GREATER GEELONG PLANNING SCHEME

DELEGATED AUTHORITY REPORT

AMENDMENT C331 & PLANNING PERMIT 392/2015 – CONSIDERATION OF SUBMISSIONS

To: Peter Smith – Coordinator Strategic Implementation
From: Stuart Thiele – Strategic Planner
Subject: Consideration of submissions
File number: C331
Date of Report: 28 November 2016

Appendix 6 – Proposed subdivision of 69-77 Cityview Drive (Submission 5)

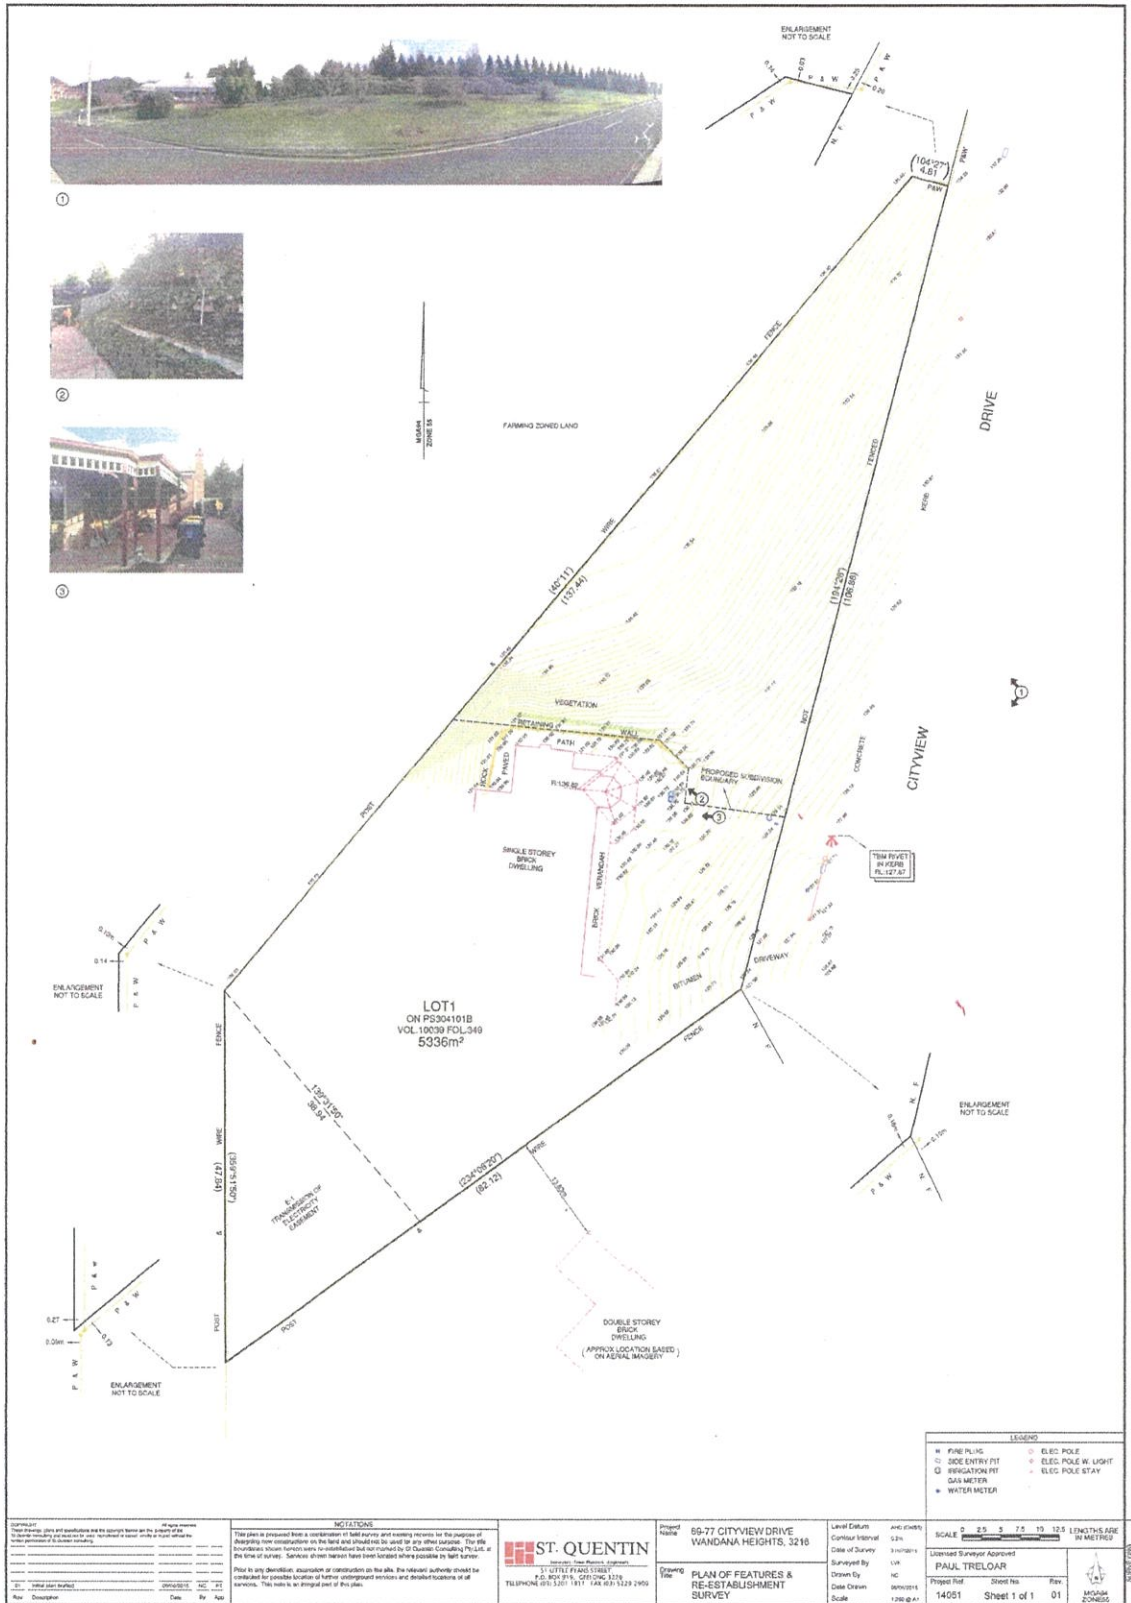
One objecting submission indicated that the objection would only be withdrawn if their property, 69-77 Cityview Drive, abutting the subject land, is included in the Amendment. The submitters wish to be able to subdivide an approximately 1700 m² lot from their 5336 m² lot (see **Appendix 6**). The current Low Density Residential Zone Schedule 2 allows for subdivision down to a minimum of 2000 m², but this is difficult to achieve due to the location of the dwelling on the submitters' land. The submitters argue that the subdivision they seek will not change the low density profile of Cityview Drive or impact neighbours.

The subdivision the submitters seek to facilitate by rezoning would be in generally in keeping with the lot sizes proposed by the Amendment; the 1700 m² lot would actually be larger than most lots proposed in the exhibited plan of subdivision. However, this change to the Amendment would require further consultation with surrounding landowners, including the beneficiaries of a restrictive covenant limiting development on each existing lot to a single dwelling. It may be considered a transformation of the Amendment. The proposed change to the zoning of the submitters' land would need to be justified by strategic assessment. It is not immediately clear that such justification exists, noting that the current zoning already provides scope for subdivision into two lots.

In light of the need for further consultation, the request to include some or all of the submitter's property in the Amendment is not supported.

Appendix 7 – Revised plan of subdivision (Submission 6)

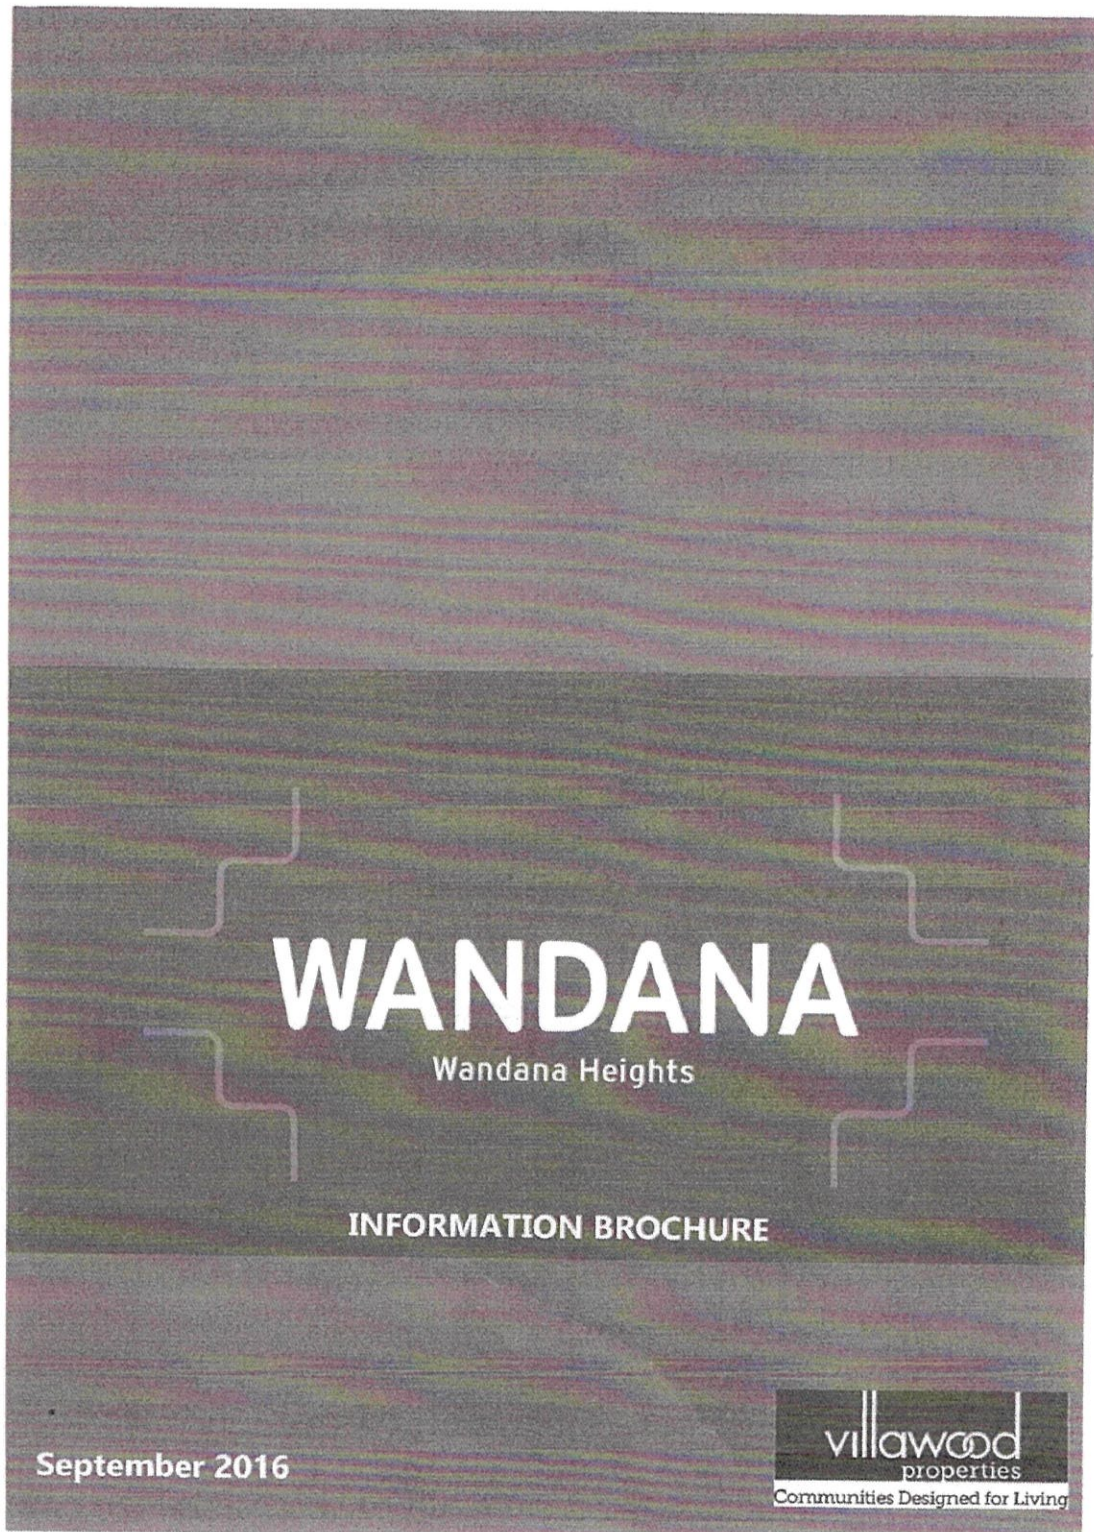
Mesh, as part of their submission, lodged and seeks support for a revised subdivision layout plan (**Appendix 7**). This proposed plan increases the number of proposed residential lots from 186 to 195. The plan also incorporates the following changes:

- the southernmost access road intersecting Cityview Drive, proposed to use the existing vehicle access to the Barwon Water site, is removed and replaced with residential lots and a reserve, for stormwater drainage reasons;
- the existing water pipe from the Barwon Water tank in the previously proposed road reserve is to be accommodated in a designated reserve;
- the central east-west pedestrian link is removed and replaced with two lots; and
- proposed Lots 1 and 2 in the north-west of the site are re-oriented to front the local access street and an extended driveway is removed.

Officer response:

Council officers have considered and support the proposed changes.
